# London Luton Airport Expansion

**8.118 Applicant's Response to Issue Specific Hearing 4  
Action 7 - Update on Road Safety Audits (Tracked Change  
Version)**

**8.118 Applicant's Response to Issue Specific Hearing 4 Action 7 –  
Update on Road Safety Audits (Tracked Change Version)**

Figure 2.1: Locations of Problems Identified within the Audit

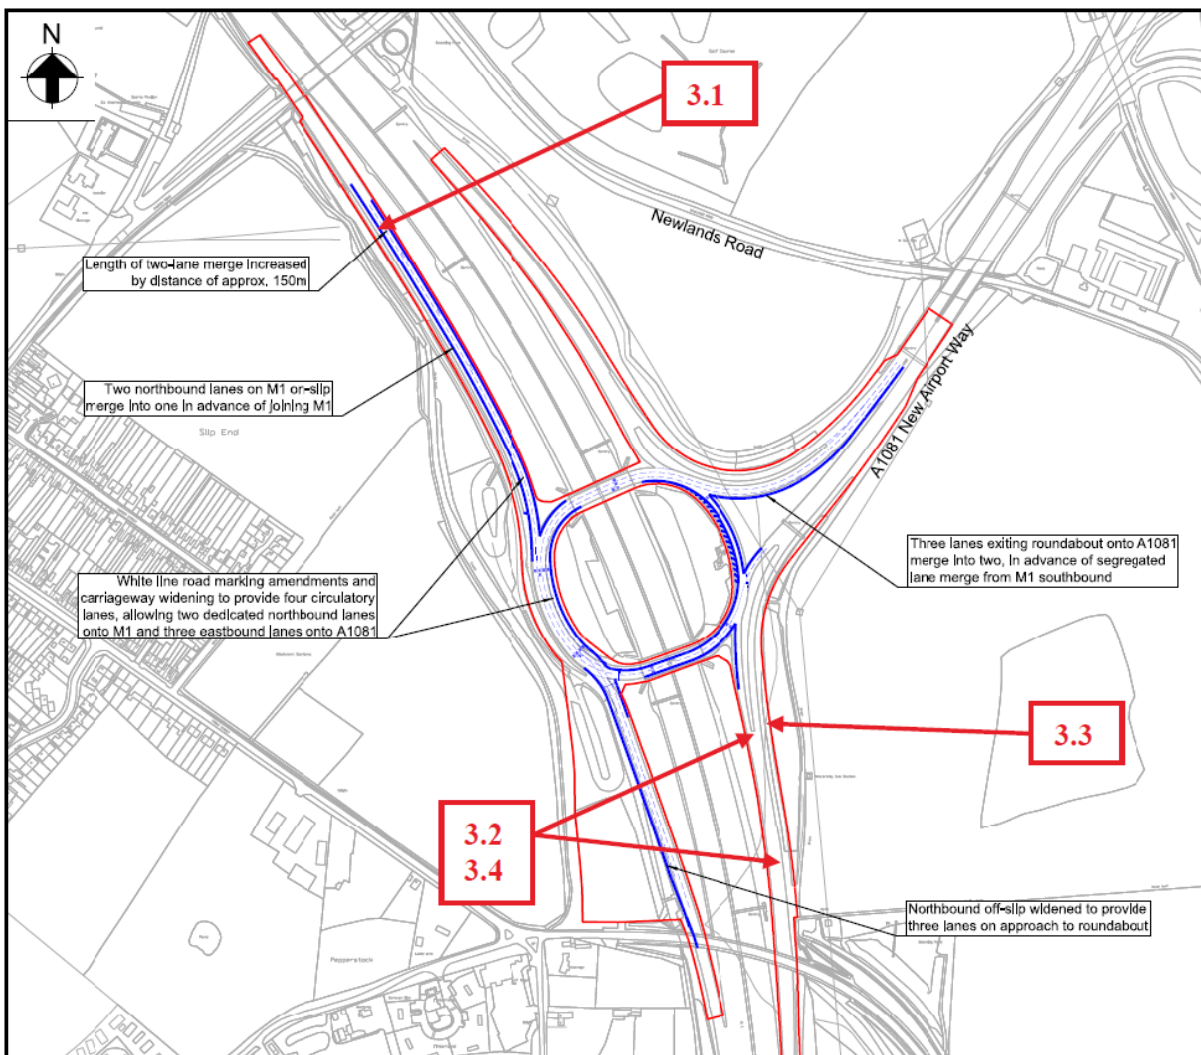
Ref.	RSA Problem	RSA Recommendation	Design Organisation Response	Overseeing Organisation Response	Agreed RSA Action
3.1	Drawing LLADCO-3C-ARP-SFA-HWM-DR-CE-0009 indicates that the length of the two-lane merge is to be extended by 150m. This may result in forward visibility of the merge point being compromised by an existing hidden dip in the northbound on-slip. This problem increases the risk of side swipe and loss of control type collisions.	Ensure that sufficient forward visibility of the merge is maintained.	Accepted. Forward visibility would be checked at the detailed design stage to ensure that appropriate visibility of the merge is maintained.	National Highways agree with the RSA. Traffic on the slip will be visible but the designer has agreed to checks.	Forward visibility would be checked at the detailed design stage to ensure that appropriate visibility of the merge is maintained.

3.3	<p>In Phase 2a and Phase 2b a two lane segregated left turn from the A1081 onto the M1 southbound slip road has been proposed. The existing southbound lane from the M1 J10 roundabout is proposed to join the segregated lanes with a short length of off-side merge. No details regarding infrastructure or stopping sight distances have been provided. Items such as VRS and signs between the segregated left turn lanes and off-side merge may obscure visibility for road users. This issue may increase the risk of side swipe, shunt, and loss of control type collisions. This</p>	<p>Provide sufficient intervisibility between the merge and segregated left turn lanes.</p>	<p>Accepted. See above response to Item 3.2 regarding the design or removal of the merge. If the exit off the circulatory is retained, there is scope to amend the alignment of the segregated left turn and separating island in order to accommodate potential VRS, signage and visibility requirements. This would be addressed at the detailed design stage.</p>	<p>National Highways agree with the RSA.</p> <p>It would be interested to explore the potential for closing the eastern circulatory or S/B merge exit as mentioned. That could remove a couple of issues, but signing for route finding would be key.</p>	<p>Amend the alignment of the segregated left turn and separating island in order to accommodate potential VRS, signage and visibility requirements. This would be addressed at the detailed design stage.</p> <p>The opportunity to close the eastern circulatory or southbound merge will be considered at the detailed design stage.</p>

Figure 2.1: Locations of Problems Identified within the Audit

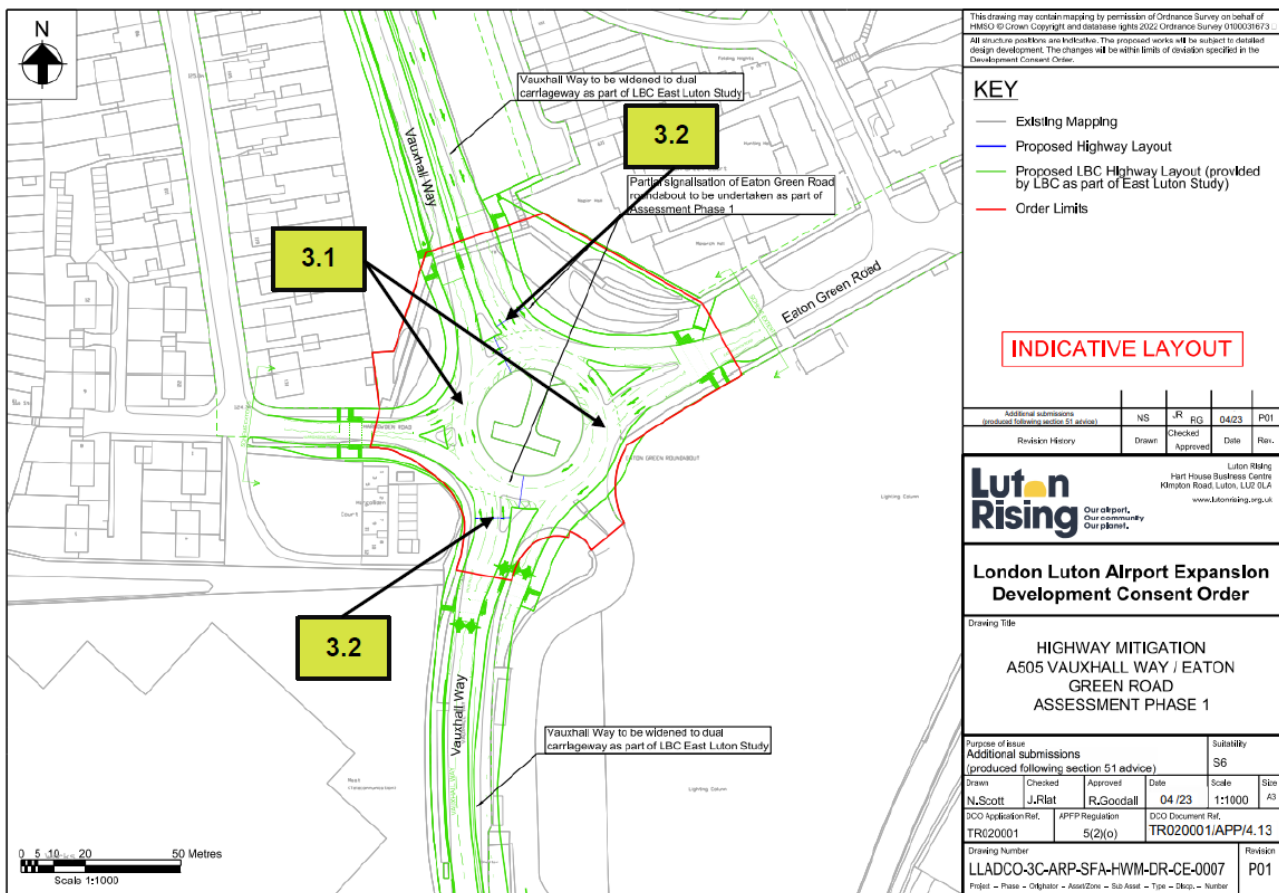
Ref.	RSA Problem	RSA Recommendation	Design Organisation Response	Overseeing Organisation Response	Agreed RSA Action
3.1	The stacking distance between successive signal stop lines is quite short, which could lead to vehicle queues extending across the Harrowden Road and Eaton Green Road entries to the roundabout. As a result, collisions could occur as road users attempt to weave through queues or change lane suddenly.	It should be ensured that the road layout and traffic signalling strategy is suitable to prevent vehicles queuing across entry arms to the roundabout.	Accepted. The operation of the signals would be optimised to ensure the efficient operation of the junction and would include consideration of queue lengths within the circulatory carriageway of the roundabout.	Design Response is accepted.	RSA recommendation to be adopted as part of the detailed design.

3.2	The widening to three lanes on the approaches to the junction could increase the likelihood of the primary signals being masked by high sided vehicles. If a red signal is not clearly visibly to road users, there could be an increased risk of overshoot collisions or accidents involving sudden and late braking, such as rear-end shunts.	High-mounted duplicate primary signals should be provided on the Vauxhall Way approaches to the junction.	Accepted. The provision of high-mounted signals would be considered at the detailed design stage.	Design Response is accepted.	RSA recommendation to be adopted as part of the detailed design.

Figure 2.1: Locations of Problems Identified within the Audit

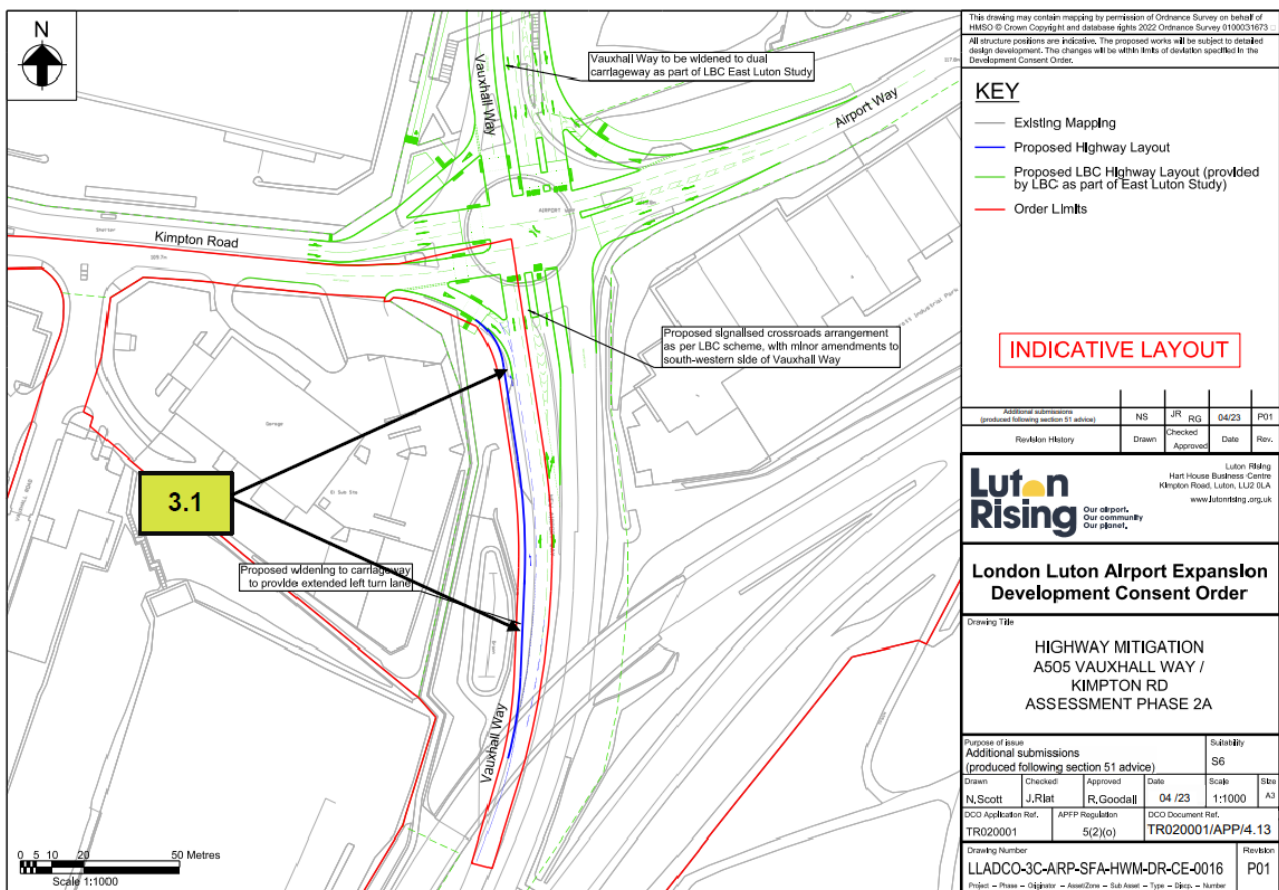
Ref.	RSA Problem	RSA Recommendation	Design Organisation Response	Overseeing Organisation Response	Agreed RSA Action
3.1	There are lamp columns and trees within the verge that will be closer to the edge of carriageway when the road is widened. A temporary vertical concrete barrier is also present, but it is not clear whether this will be retained. If not, the lamp columns and trees could present a roadside hazard to road users if they lose control and collide into the objects. Injuries could be serious if vehicles are brought to an abrupt halt or redirected violently.	A suitable vehicle restraint system should be provided, unless the lamp columns are replaced by passively safe systems and any mature trees removed that will be close to the edge of carriageway.	Accepted. This would be addressed at the detailed design stage.	Design Response is accepted.	RSA recommendation to be adopted as part of the detailed design.

Figure 2.1: Locations of Problems Identified within the Audit

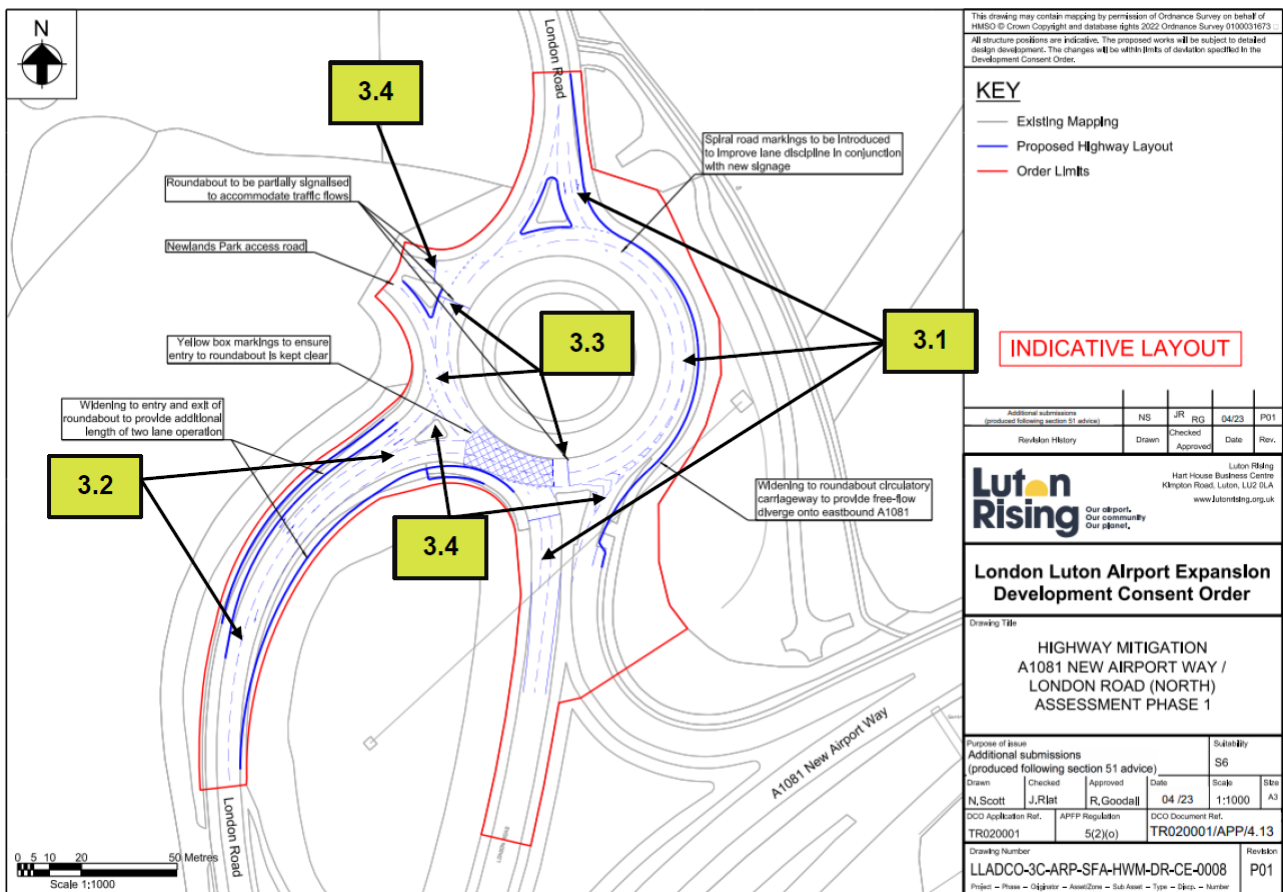
Ref.	RSA Problem	RSA Recommendation	Design Organisation Response	Overseeing Organisation Response	Agreed RSA Action
3.1	Road users may not be able to anticipate which lanes to use to reach their intended destination. For example, on the A1081 approach, road users may use the middle lane to reach London Road (north) rather than the designated offside lane. On the London Road southbound approach, road users may use the offside lane to reach the A1081 (which they can currently), instead of using the nearside lane only. If road users find that they are in the incorrect lanes, side swipe and lane change collisions could occur.	Lane destination signs and road markings should be provided at strategic locations to inform road users of the correct lanes to use.	Accepted. Lane markings and signage would be provided to clarify which destinations are reached from each approach lane. This would be addressed at the detailed design stage.	Design Response is accepted.	RSA recommendation to be adopted as part of the detailed design.

Ref.	RSA Problem	RSA Recommendation	Design Organisation Response	Overseeing Organisation Response	Agreed RSA Action
3.3	The stacking distance between successive signal stop lines is quite short, which could lead to vehicle queues extending across the London Road southern entry to the roundabout. As a result, collisions could occur as road users attempt to weave through queues or change lane suddenly.	It should be ensured that the road layout and traffic signalling strategy is suitable to prevent vehicles queuing across entry arms to the roundabout.	Accepted. The operation of the signals would be optimised to ensure the efficient operation of the junction and would include consideration of queue lengths within the circulatory carriageway of the roundabout.	Design Response is accepted.	RSA recommendation to be adopted as part of the detailed design.

3.4	The widening of the roundabout could make crossing movements more hazardous for pedestrians and cyclists, especially at times of high vehicle flows (peak times) or when speeds could be higher at off-peak times. This could be a particular issue on the London Road southern arm and on the A1081 exit arm. On the Newlands Park access entry to the roundabout, the position of the signal stop line could make it difficult to provide a crossing point. Vulnerable road users could be at increased risk of being struck by vehicles under such circumstances.	It should be ensured that the pedestrian and cycle crossing points will be safe to use (for example, controlled crossings may be beneficial at some locations).	Noted. The proposed realignment on the A1081 exit arm increases the crossing distance by approximately 1.0m and could be reduced at the detailed design stage to minimise any additional crossing distance.  The pedestrian demand on the London Road (south) exit arm is likely to be very low, and the proposed signalisation of the A1081 arm should create gaps in the traffic for pedestrians to cross. In addition, the widening to the London Road exit is c1.5m and would only add c.1 second to the crossing time for pedestrians.	Design Response is noted. Recommend that non-motorised user demand is reviewed as part of the detailed design.	RSA recommendation is noted and overseeing organisation comment accepted.

Ref.	RSA Problem	RSA Recommendation	Design Organisation Response	Overseeing Organisation Response	Agreed RSA Action
			<p>The position of the stop line at the exit from Newlands Park would be adjusted to accommodate a pedestrian crossing at the detailed design stage.</p>

Figure 2.1: Locations of Problems Identified within the Audit

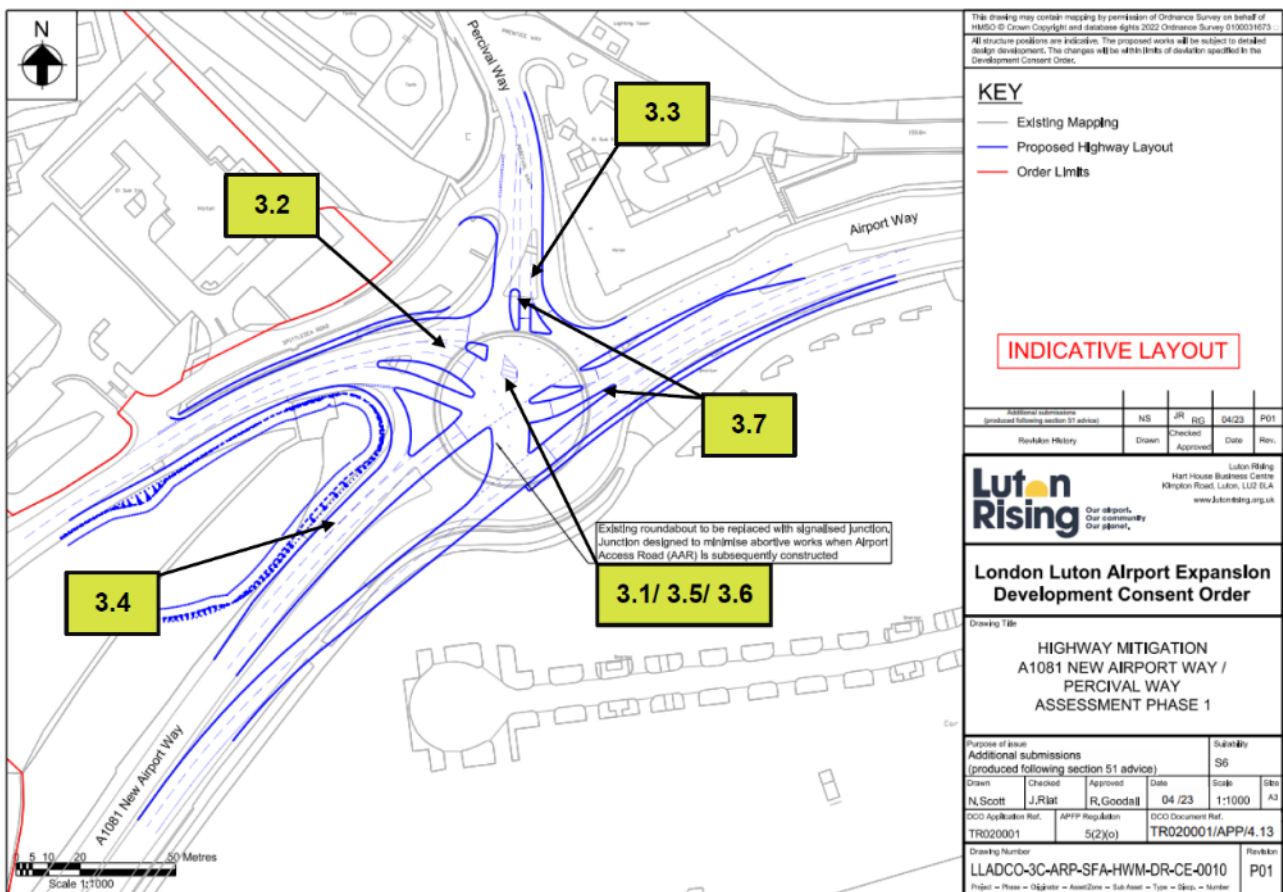
3.7	It is not known at this stage if there are going to be any controlled crossing facilities at the proposed signalised junction. It is noted that for Airport Way and Percival Way there are existing shared footway/ cycleways and uncontrolled crossing facilities which link to a nearby hotel and car park area. With the new multilane signalised arrangements with greater crossing distances this could increase the risk of collisions with pedestrians and cyclists.	Pedestrian and cyclist movement should be reviewed around the junction and appropriate controlled crossing facilities should be installed where required such as Toucan crossings. These should also be compliant with the latest cycling guidance, such as LTN 1/20.	Accepted. There is flexibility within the junction design to accommodate crossing facilities on existing desire lines and this would be considered at the detailed design stage.	Design Response is accepted.	RSA recommendation to be adopted as part of the detailed design.

Figure 3.1: Swept Paths - Frank Lester Way / Eaton Green Road

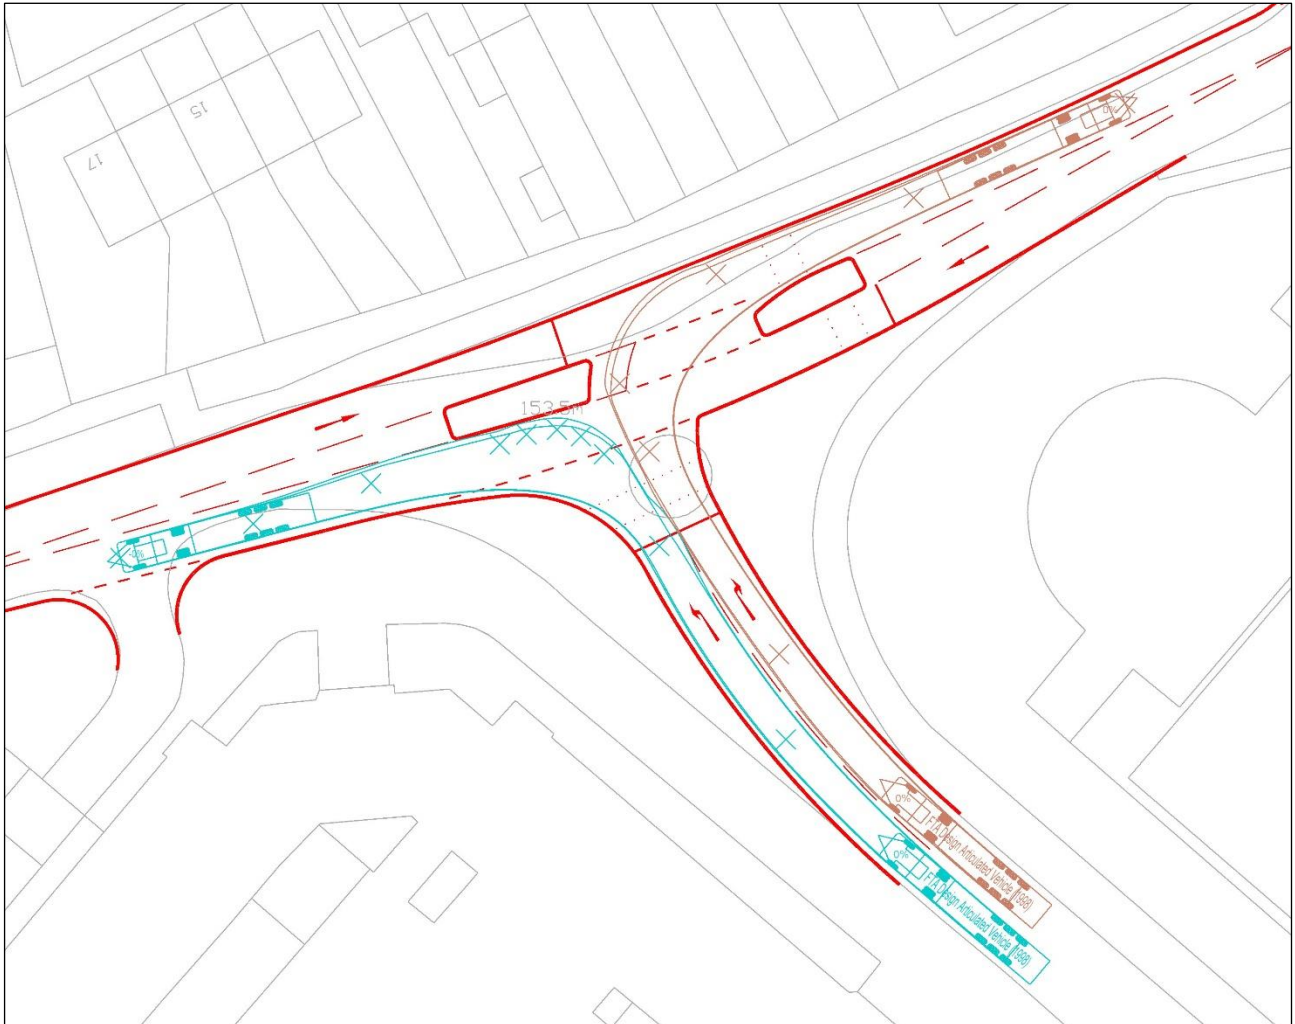
Ref.	RSA Problem	RSA Recommendation	Design Organisation Response	Overseeing Organisation Response	Agreed RSA Action
	result, they may mount the kerbs or strike street furniture, creating a hazard to other road users or pedestrians walking along the footway.	geometry of the junction amended if required.	into Eaton Green Road was achievable for vehicles including articulated HGVs and buses – see Figure 3.1	checked at subsequent design stages.	at subsequent design stages.

3.2.1 Figure 3.1 above shows the swept path analysis for 16.5m articulated HGV manoeuvres at the proposed signalised junction between Frank Lester Way and Eaton Green Road.
